MEMORANDUM

Re: Automotion-Giroux Site Plan Amendment - Follow-up Information

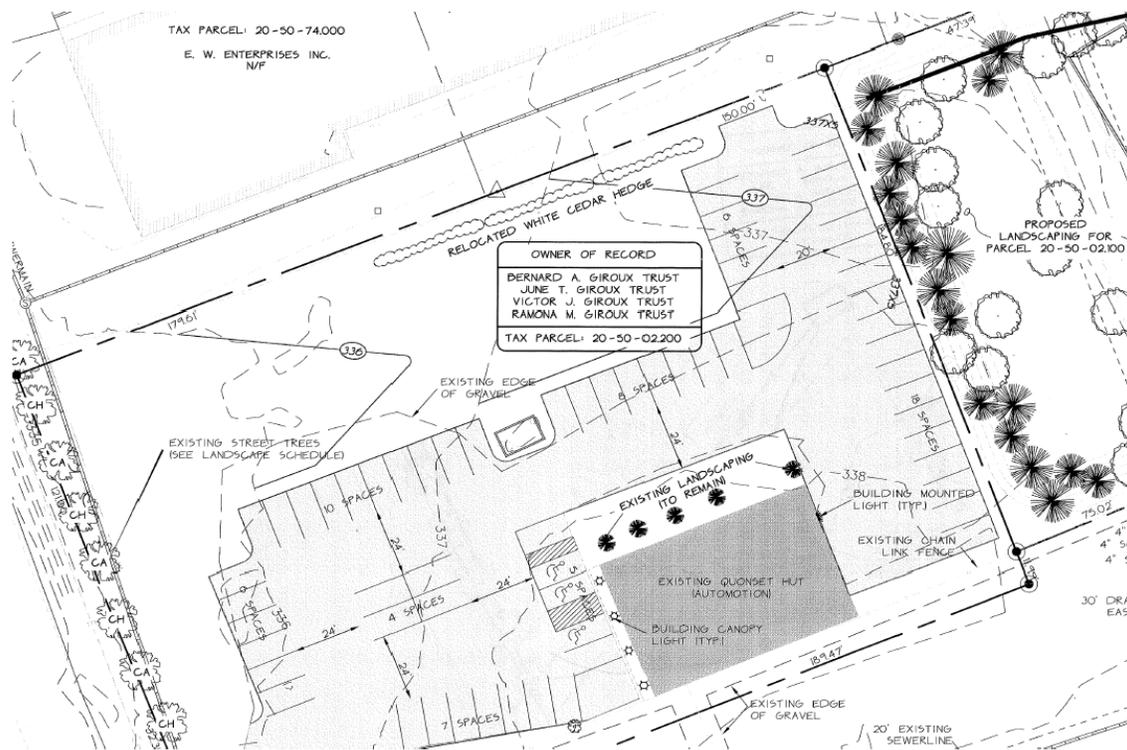
Town Follow-up (11/12/13): Based on the site plan below it appears that the new contours will take all the water from the site to the north starting at the new eastern property line. While difficult to read, the existing contours indicate that the portion of the property located in the vicinity of the north east parking area currently drains to the northeast into the existing swale near Darkstar. Please comment.

Town Follow-up (11/12/13): As well please explain the discrepancies between the site plan presented for the Hannaford approval and this one. Specifically the swale

created in the NE corner of the property in the Hannaford plan and the new drainage plan for the Automotion lot.

Applicant Follow-up (11/26/13): Stormwater from Parcel 20-50-02.100/Lot 15 was designed to flow to the Hannaford stormwater system where it will be treated, detained, and then released into the Darkstar swale. This includes the designated farmers market space directly east of the Automotion site.

The northeast corner of the Automotion site currently flows northeast to the Darkstar swale. This application proposes that the new parking in that northeast corner be graded to flow west into the existing drainage ditch along VT 116 and not into the Darkstar swale. By doing this, stormwater is allowed to sheet flow approximately 230 feet across open lawn area and thus, the level of stormwater treatment is expected to improve over current conditions.

Applicant Follow-up (11/26/13): This application does not alter the Town-approved Hannaford stormwater plans for the area to the east of the Automotion site. At the time of the Hannaford proposal, no work was planned on the Automotion property so no site changes to Automotion were proposed. As described above, this application proposes to slope the proposed parking area to drain west, which will provide better treatment because the over-land flow increases from 100 feet (current conditions) to 230 feet (proposed conditions) before the VT 116 ditch.
